# UNITED STATES PATENT AND TRADEMARK OFFICE

APPLICATION NO.	FILING DATE	FIRST NAMED INVENTOR	ATTORNEY DOCKET NO.	CONFIRMATION NO.
10/789,357	02/27/2004	John Popovich	PERMLT.019C1	5148
20995	7590	04/13/2005	EXAMINER	
KNOBBE MARTENS OLSON & BEAR LLP			TSO, LAURA K	
2040 MAIN STREET			ART UNIT	
FOURTEENTH FLOOR			PAPER NUMBER	
IRVINE, CA 92614			2875

<b>Office Action Summary</b>	Application No. 10/789,357	Applicant(s) POPOVICH ET AL.	
	Examiner laura tso	Art Unit 2875

## DETAILED ACTION

FIG. 16

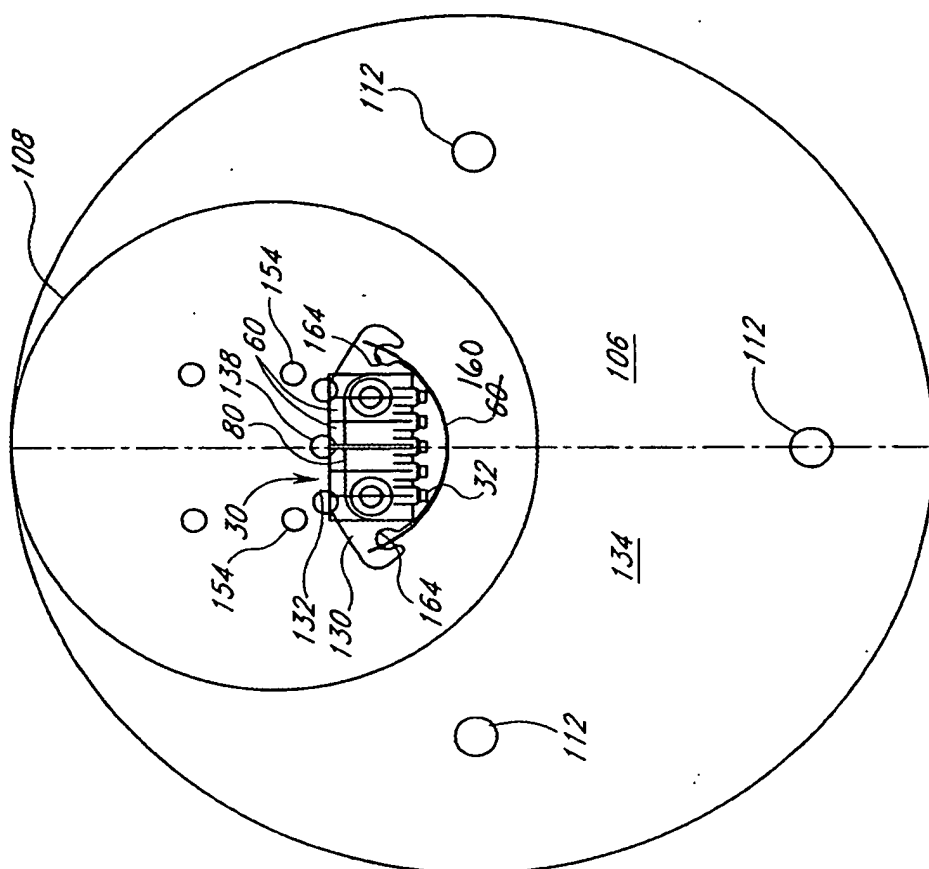
The drawings are objected to because in figure 16, applicant should change "60" to --160-- (note attachment). Corrected drawing sheets in compliance with 37 CFR 1.121(d) are required in reply to the Office action to avoid abandonment of the application. Any amended replacement drawing sheet should include all of the figures appearing on the immediate prior version of the sheet, even if only one figure is being amended. The figure or figure number of an amended drawing should not be labeled as "amended." If a drawing figure is to be canceled, the appropriate figure must be removed from the replacement sheet, and where necessary, the remaining figures must be renumbered and appropriate changes made to the brief description of the several views of the drawings for consistency. Additional replacement sheets may be necessary to show the renumbering of the remaining figures. Each drawing sheet submitted after the filing date of an application must be labeled in the top margin as either "Replacement Sheet" or "New Sheet" pursuant to 37 CFR 1.121(d). If the changes are not accepted by the examiner, the applicant will be notified and informed of any required corrective action in the next Office action. The objection to the drawings will not be held in abeyance.
